1964 Corvette: Service Bulletin: 4-Speed Shift Lever Revision

Source: Chevrolet Technical Service Bulletin

Bulletin No: DR #691

Date: September 8, 1964

FIG. 2 - EARLY THREAD

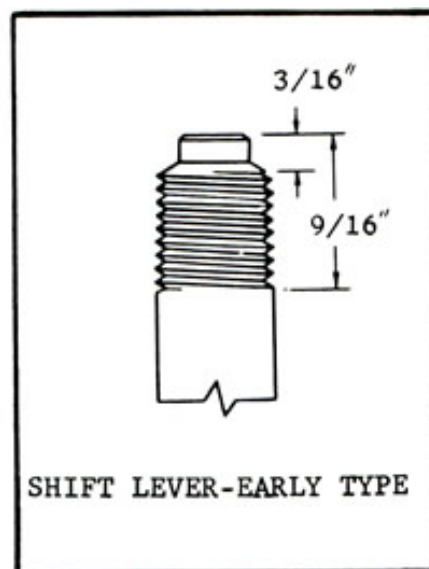
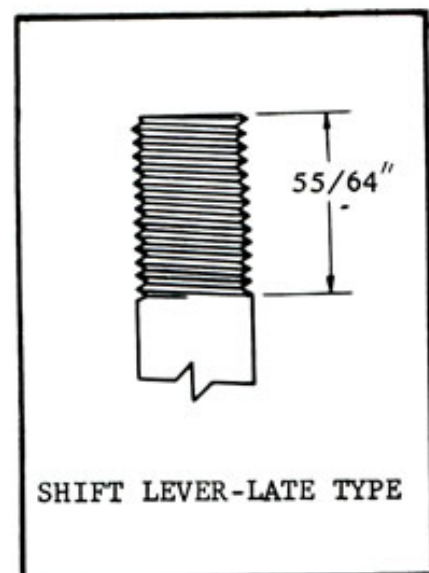
Two shifter knob designs and two shift lever thread designs have been used in 1964 production. The early design all plastic knob, part number 3846842, may be used on either lever. The late design knob, which has a threaded brass insert sleeve, can be used only on the late design lever. Refer to Figures 2 and 3 for details.

Regardless of lever or knob design, the threads must be free of burrs. The slot edges of the threads should be chamfered and smooth. When installing a knob, use extreme care to avoid cross-threading.

FIG. 4 - MODIFICATION OF SHIFT LEVER LOWER END

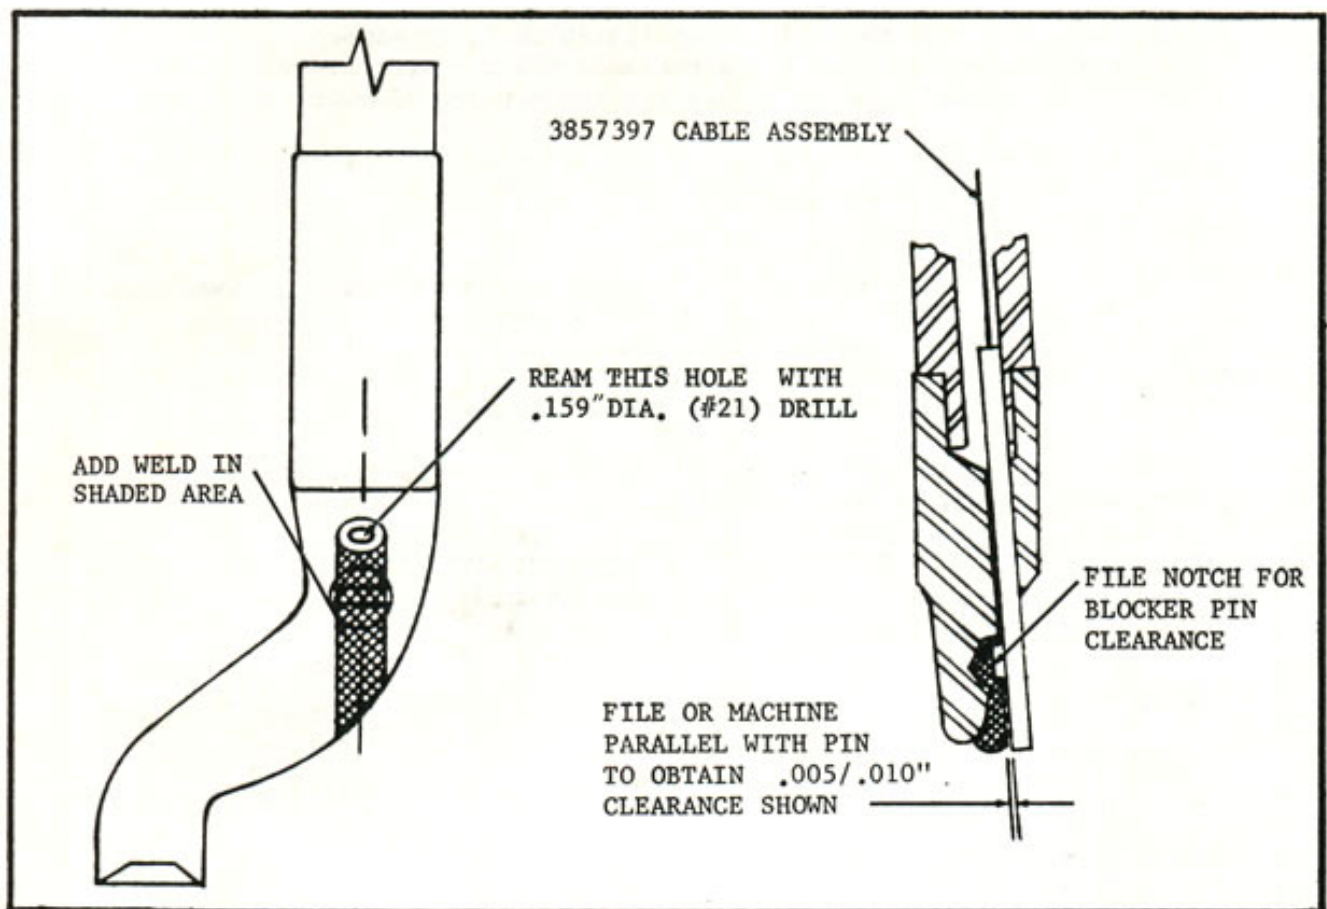
REVERSE INHIBITOR BINDS

2. Add a heavy weld or brass bead to the shift lever as shown by the shaded section of Figure 4.
3. File the bead flat and parallel to the reverse inhibitor pin with .005" to .010" clearance to the pin.
4. Remove and discard the pin and wire assembly from the "T" handle and enlarge the "T" handle hole to .082" with a 5/64" drill. Reassemble using the new pin and wire assembly, part number 3857397.

FIGURE 5 - REVERSE BLOCKER PIN LOCATING DETAILS

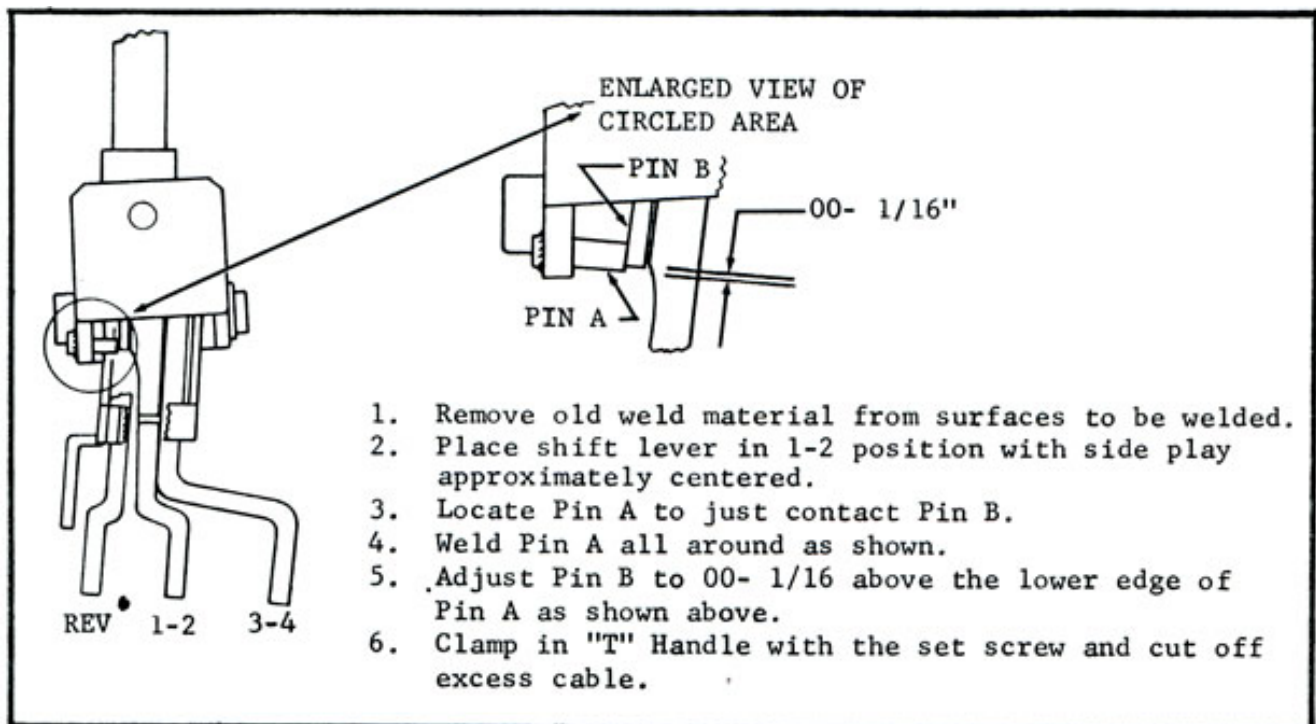
REVERSE BLOCKER PIN LOOSE OR MISSING

If the reverse blocker pin weld has broken, Figure 5 describes the proper locating dimensions for rewelding. If the original pin has been lost or damaged, a 1/4 inch by 5/8 inch hardened bolt, such as part no. 9409073, may

be used. The shift mechanism must be fully assembled before welding the pin so that the proper pin location may be achieved.
